MILITARY SPECIFICATION SHEET

LOUDSPEAKER, PERMANENT MAGNET (ENCASED, 2-WATT, FUNGUS-, GUNBLAST-, AND IMERSSION-RESISTANT), TYPE LS-454/U

This amendment forms part of Military Specification Sheet MIL-L-12632/4A, dated 10 June 1974, and is approved by all Departments and Agencies of the Department of Defense.

FIGURE 3. Audio transformer

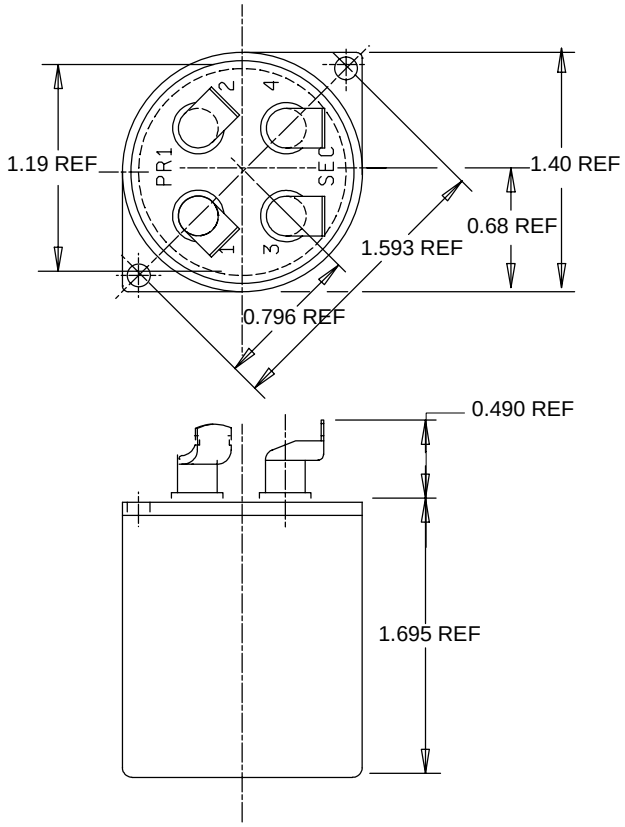
PAGE 3: FIGURE 3: Delete and substitute :

Audio transformer: Delete and substitute the following:

"Audio transformer - Type TF4R21YY of MIL-T-27/2 (P/N M27/2-01) in accordance with MIL-T-27 (see figure 3)."
